**RE: Gulf Power Company
Scholz Electric Generating Station
NPDES Permit No. FL0002283
Renewal Application Request for Additional Information (RFI) #2**

**Response to FDEP Biology's Comments (March 5, 2010) on
Plant Scholz 316(b) Impingement Mortality Study
(Document dated November 2009) prepared
by MACTEC (on behalf of Gulf Power)**

**Response to FDEP Biology review (dated March 5, 2010) of
Gulf Power Company Scholz Electric Generating Plant
“Hester-Dendy Identification and Enumeration Report” (dated November 2009)**

**Response to FDEP Biology's Comments (March 5, 2010) of
Gulf Power Company Scholz Electric Generating Plant
"Scholz Stream Condition Index Report" (dated November 2009)
prepared by MACTEC (on behalf of Gulf Power)**

**Figure
 1**

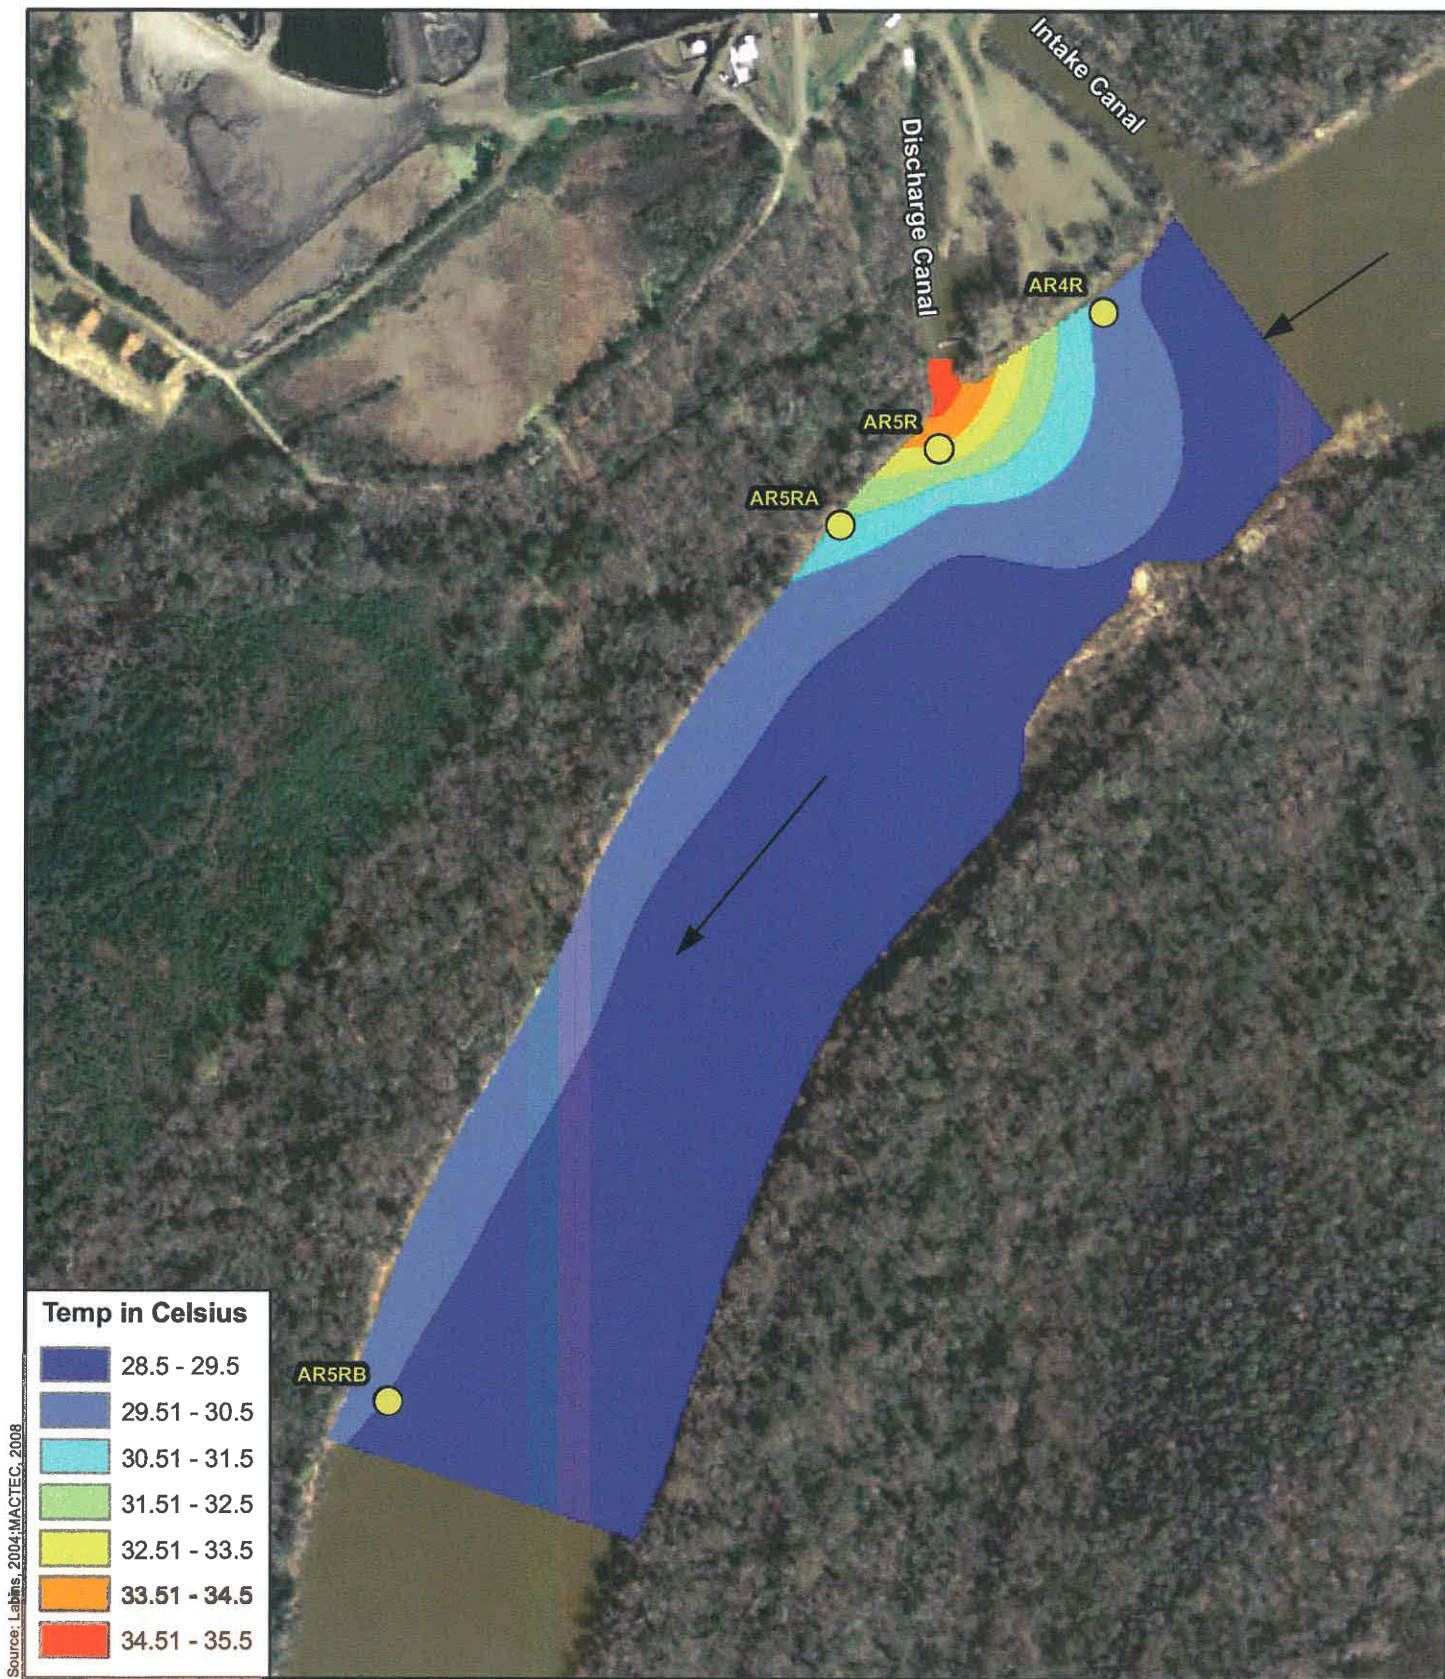
- 1) The map provided as part of the Proposed Biological Monitoring Plan does not use the same site names or identify the placement of the Hester-Dendy (HD) samplers in this study. The distances or relationships between the placement of the HDs and the intake canal, discharge canal, and banks of the Apalachicola River are not specified in the report. Please provide site location information. A map would be helpful.

Response: MACTEC performed a thermal plume investigation at Plant Scholz for Gulf Power in July 2008; however, the report was inadvertently not included in the 2009 NPDES submittal. During the 2009 sampling, Plant Scholz was not operating, therefore, the Hester-Dendy study completed in 2009, is not a thermal plume investigation. A summary of the methods, results, and discussion of the 2008 thermal plume study are presented below.

Measurements were taken along two transects upstream of the outfall and four transects downstream of the outfall (Figure 1). Measurements were taken at three locations across the transects: at the right bank (looking downstream), the middle of the channel, and at the left bank. The Plant Scholz cooling water discharge canal enters the river on the right side (looking downstream) of the Apalachicola River. The reach where temperature monitoring occurred is approximately 1 mile in length.

Figure 6. USGS Hydrograph for the Apalachicola River at Chattahoochee, FL May- July, 2009

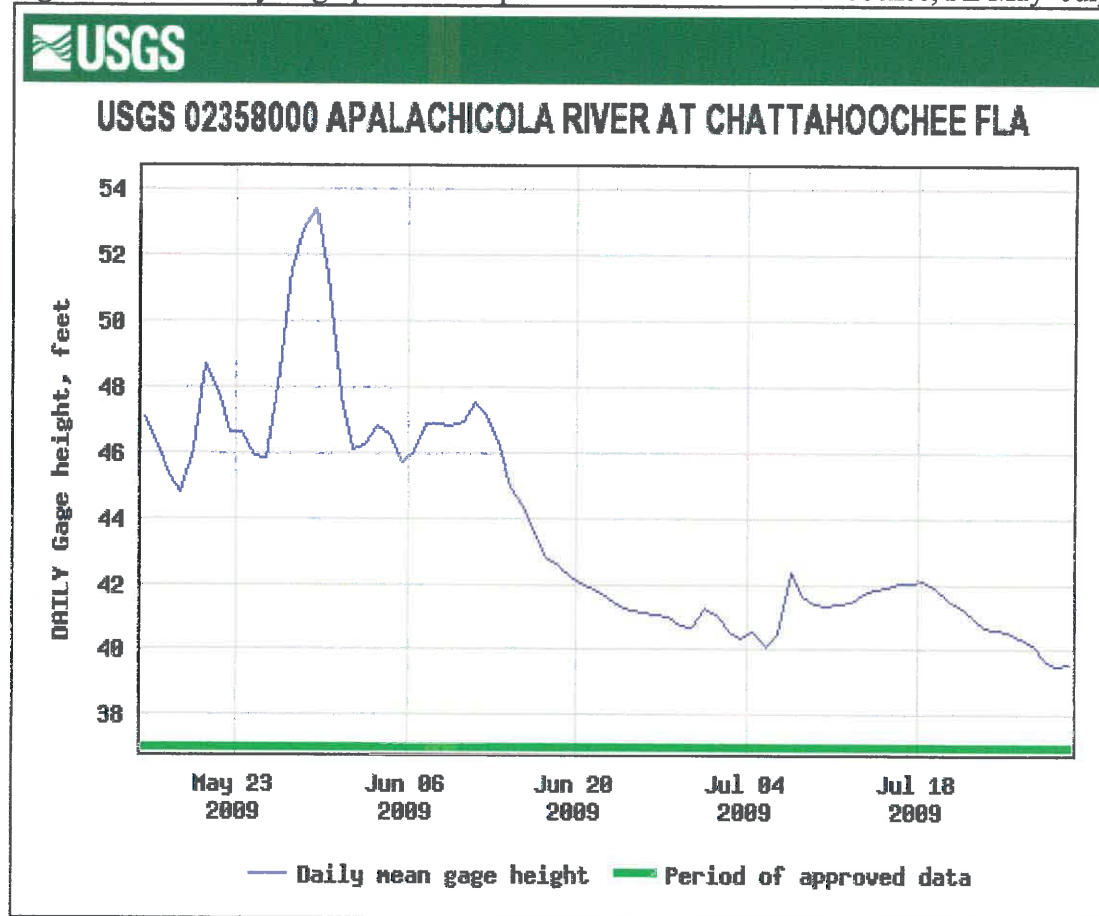
- 3) The Proposed Biological Monitoring Plan states the HDs will be anchored 1 ft above the streambed in 1.5m of water. What was the actual deployment depth below the surface? This is important for the following reasons.

- First, a 1.5 m deployment depth is beyond the 1 m deployment depth specified in DEP’s Standard Operating Procedures for Biological Communities (DEP-SOP-001/01 FS 7000 General Biological Community Sampling). Second, attachment 1 of the “Scholz Stream Condition Index Report, November 2009” is a hydrograph of this portion of the Apalachicola River and shows a change in gage height of approximately 0.5m over the study period. This suggests that if HDs were anchored, they may have been even deeper for a portion of the deployment. The FDEP SOP provides the option of floating HDs or, if flow regime or potential for vandalism is great, using both floating and anchored. The Department cannot accept data that wasn’t collected according to FDEP Standard Operating Procedures.

- a. The placement of the artificial substrate samplers in the vertical water column, instead of using surface floating platforms, was chosen primarily to reduce the problem of vandalism which has been a problem at this site in the past. The Hester-Dendy samplers were deployed on June 10, 2009. They were placed approximately 1 ft above the streambed in approximately 5 ft water depth, approximately 4 ft (1.22 m) below the water surface. Following deployment, water levels continued to drop in the Apalachicola River in the vicinity of Plant Scholz (See Figure 6); therefore, Gulf Power personnel moved the Hester-Dendys to a deeper location to maintain a depth of approximately 1 meter from the water surface. The Apalachicola River is often dynamic and dependent on the Jim Woodruff dam, just upstream of the Scholz Power Plant. Gulf Power conducts macroinvertebrate sampling every year because of the site specific difficulties associated with the sampling methodology. In 2009 with the fluctuating hydrology and the plant not operating, the data collected should not be used to evaluate thermal plume impacts. Future sampling will consider the use of both floating and anchored Hester-Dendy samplers.
